## APPENDIX C3. Pre-Submission Consultation June-August: Breckland Council Comments with STNP Responses

### Saham Toney Neighbourhood Plan

#### Breckland Council comments for the Third Regulation 14 Consultation

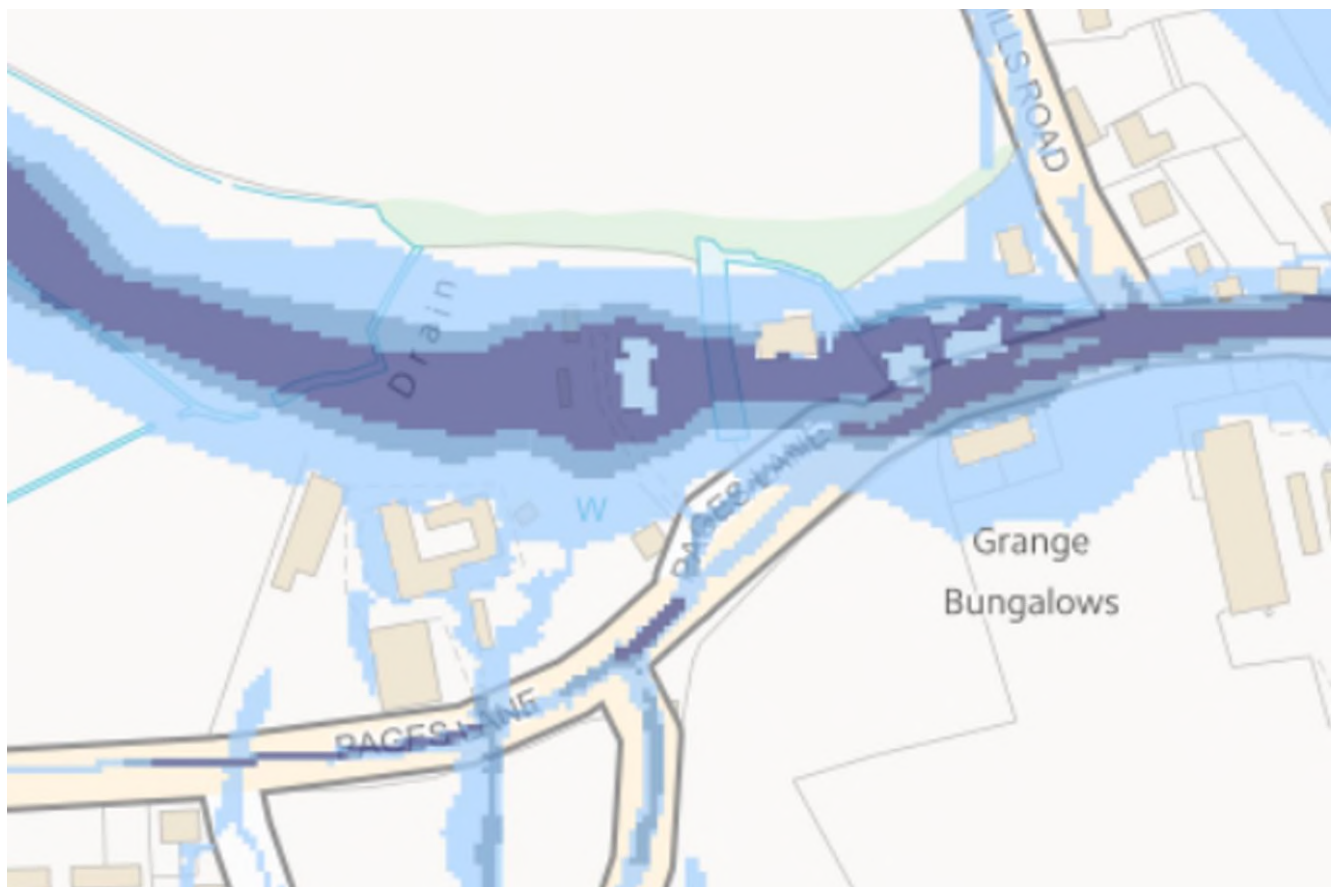
The mocked-up picture below shows the slightly wider picture in your area. As you can see, we reduced the site size from what was proposed by the owners such that it avoids the area of highest

flood risk. I have only shown that risk area approximately but I also include below the detailed risk map of the area for your reference, the darkest shade being the highest risk. As I hope you will appreciate, the green area above serves a dual purpose in that it is also intended as a means of conserving the setting of Page's Place.
